BRUNSWICK STEAM ELECTRIC PLANT, UNIT 2
NRC DOCKET NO. 50-324
OPERATING LICENSE NO. DPR-62
REQUEST FOR LICENSE AMENDMENT
FUEL CYCLE 12 RELOAD LICENSING

TYPED TECHNICAL SPECIFICATION PAGES - UNIT 2

FIGURE 3.1.5-1

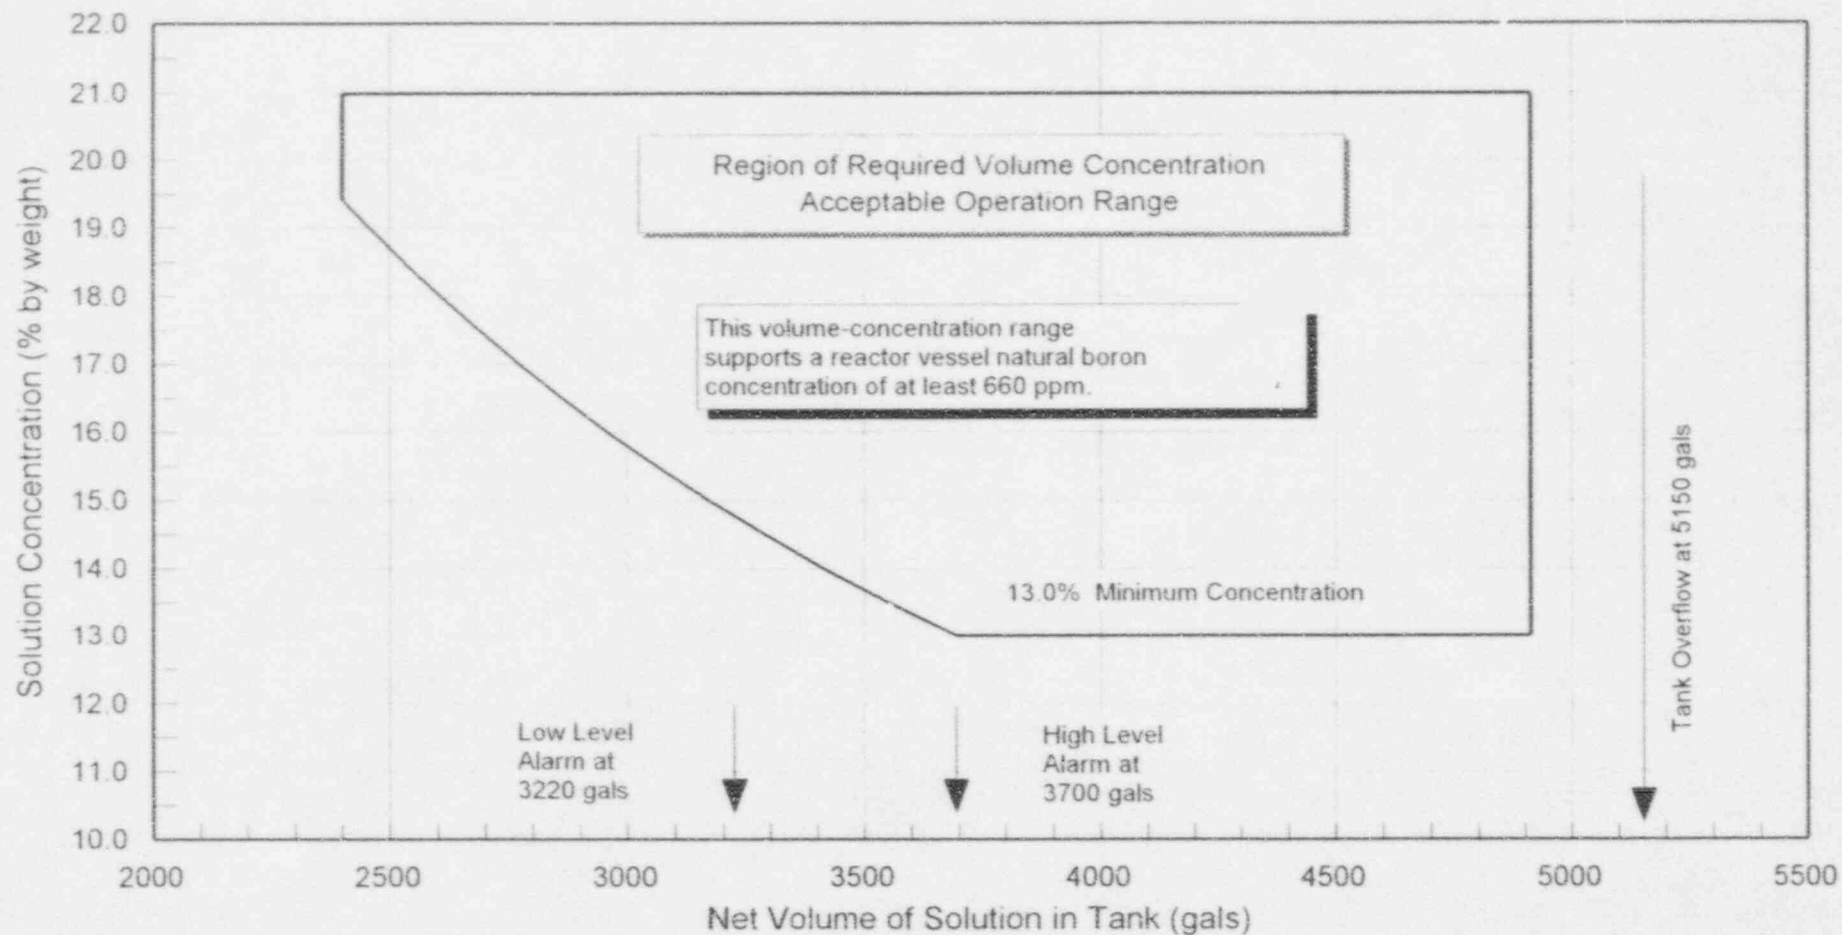
Replace with
attached figure.
